U. S. Nuclear Regulatory Commission  
Attn: Document Control Desk  
Washington, D.C. 20555Subject: Peach Bottom Atomic Power Station, Unit 2  
Core Spray In-Vessel Piping

A/R SUBJECT: UNIT 2 MOD P00335 - CORE SPRAY DOWNCOMER REPAIRS

MOD# P00335

MOD DESCRIPTION: REPAIR OF CORE SPRAY DOWNCOMER CRACKS

FIGURE 1

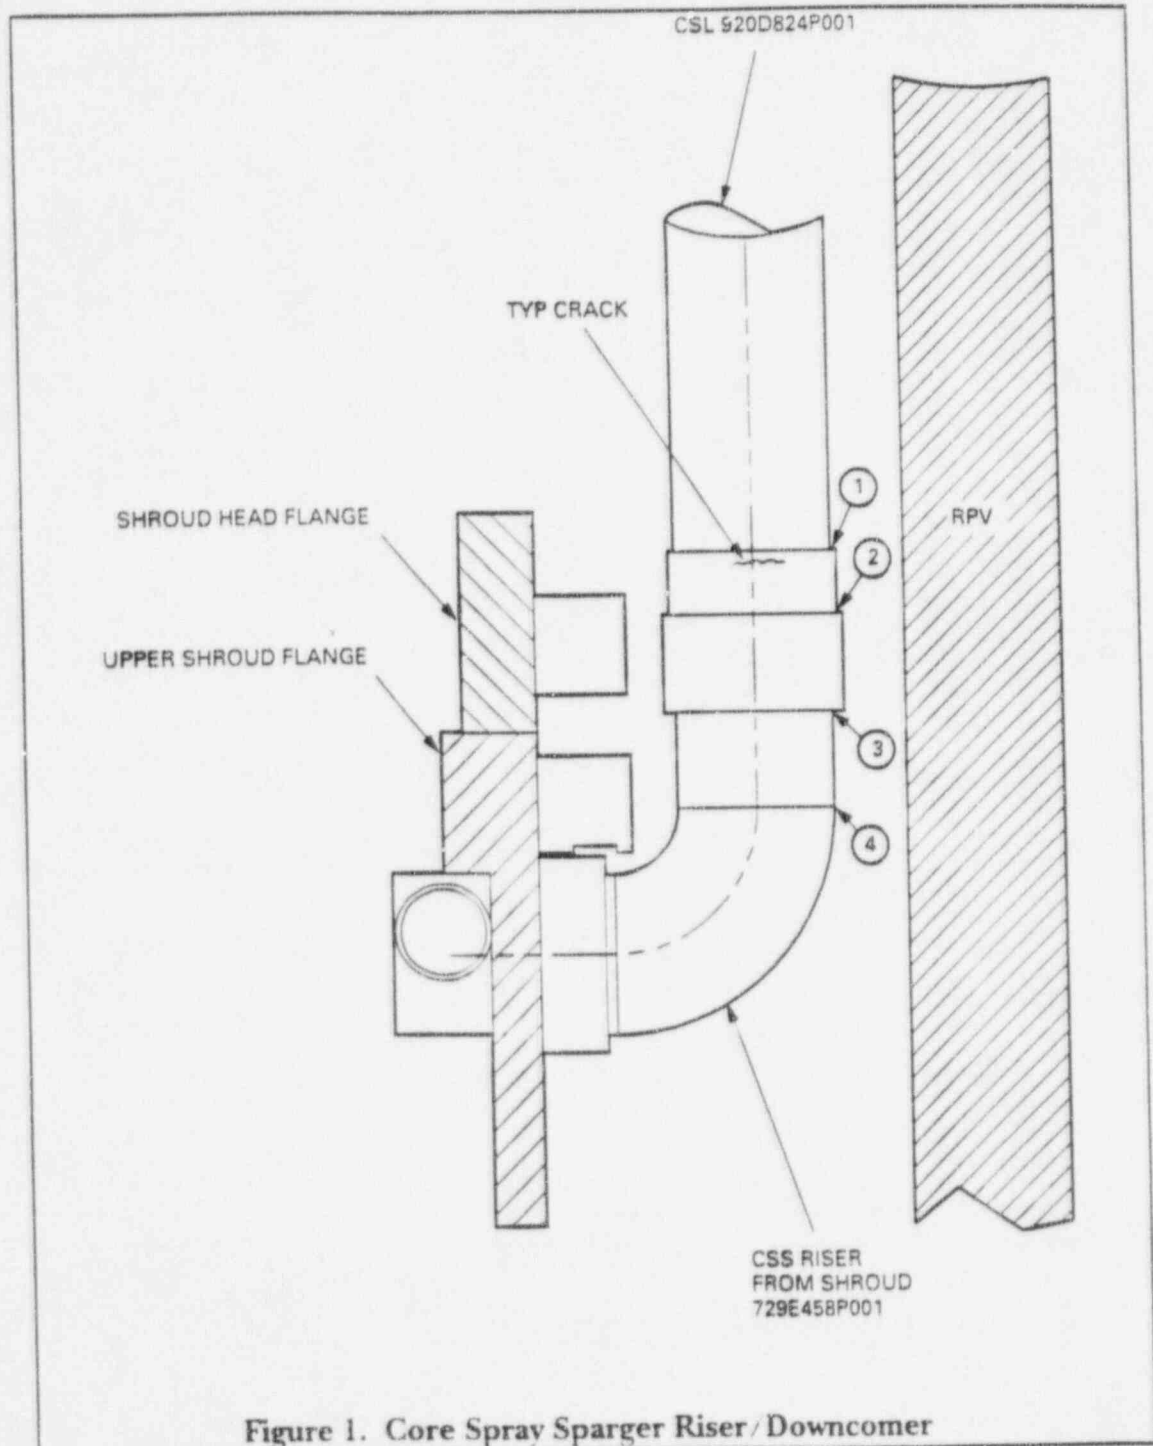
accidents are evaluated in the UFSAR. The existing core spray downcomer and repair clamps do not function to mitigate the consequences of any UFSAR event except the design basis LOCA event. No UFSAR dose calculation will be impacted by this change. For the design basis LOCA event discussed in the UFSAR, the core spray line and downcomer provide the flow path inside the RPV for the ECCS flow to the core spray spargers. Maintaining this flow path is required to ensure that core reflooding capability is maintained following the design basis LOCA. This repair design, through its restraint of the joint, ensures the integrity of the core spray downcomers, with 360 degree through-wall cracks in locations from the HAZ below weld 1 through weld 4 of Figure 1, under DBA conditions.

The design of the modification assumes the postulated cracks at location from the HAZ below weld 1 through weld 4 of Figure 1 will grow to 360 degree through wall. The installation of the downcomer repairs will limit the separation between downcomer and riser to 0.062 inch for the "B" loop downcomers and 0.041 inch for the "A" loop downcomers. This maximum separation results from the temporary cooling of the CS riser relative to the newly installed U-bolt. It is conservatively assumed that the U-bolt is still at 550 degrees F when the CSS riser is cooled to 310 degrees F, average temperature, by the injected water from the torus (240 degree F water temperature difference). After a few minutes of post LOCA core spray system injection, the riser pipe and U-bolt temperatures will reach an equilibrium. However, due to anticipated displacement of a loose spool piece of pipe in the multiple crack situation, the total width of the cracks may remain at to 0.062 inch for the "B" loop and 0.041 inch for the "A" loop.
